Re: Finance Docket No. 35095, The Alaska Railroad Corp. -- Petition For An Exemption
From 49 U.S.C. §10901 To Construct and Operate a Rail Line Extension to Port
MacKenzie, Alaska

Per your August 13, 2009 request, and on behalf of Alaska Railroad Corporation and with the support of the Matanuska-Susitna Borough, enclosed please find our comments concerning Chapter 2 of the DEIS in regard to the above-captioned proceeding.

2. PROPOSED ACTION AND ALTERNATIVES

Figure 2-1. Cross-Sections of Rail Line Right-of-Way

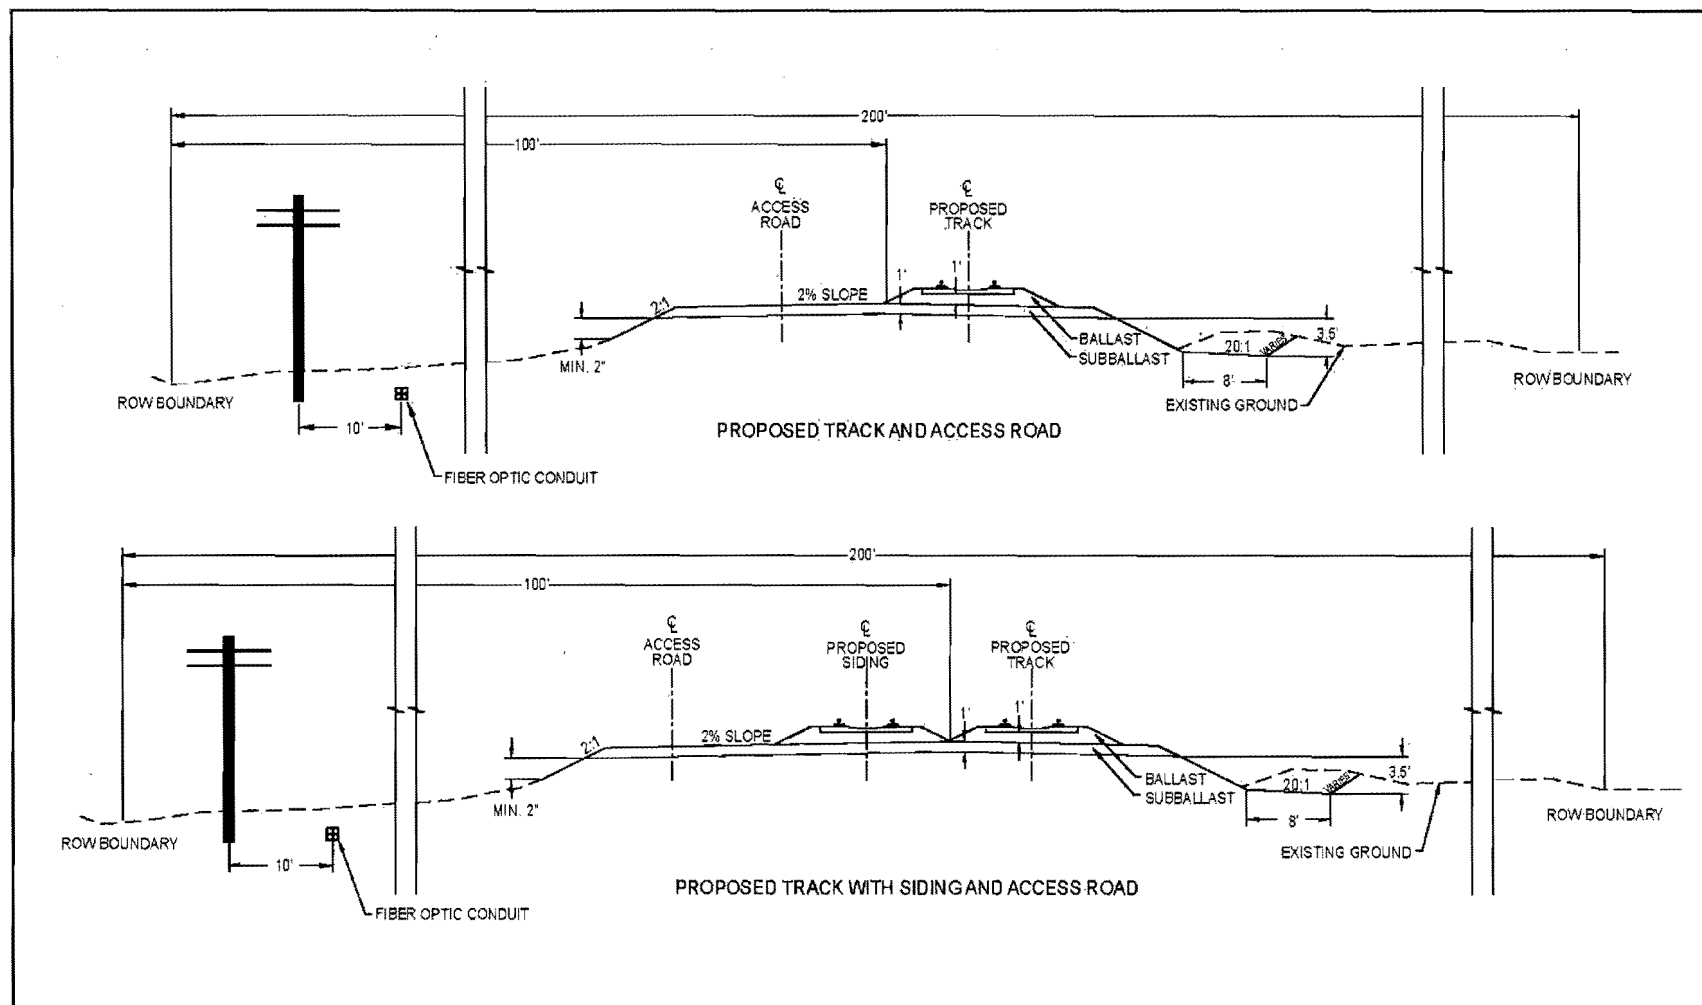
ARRC proposes a ~~200-foot~~ wide right-of-way (ROW) of approximately 200 feet for the rail line. Unless otherwise noted, this EIS assumes that all construction activities would occur within this 200-foot-wide ROW. ARRC might reduce the width of the ROW, as necessary, to minimize impacts to sensitive resources or accommodate the terrain. The ROW ~~would~~ could contain a power line, a buried ~~communications cable~~ utility lines, and an access road (see Figure 2-1). In addition, ARRC would construct one rail line siding within the existing main line ROW at the tie-in location with the rail extension. The area in the ROW that is cleared of vegetation for construction, but not needed for permanent structures, would be restored to natural conditions, to the extent practicable, consistent with rail line operating requirements. ARRC would need to acquire ~~state~~ public and private lands to establish the linear ROW.
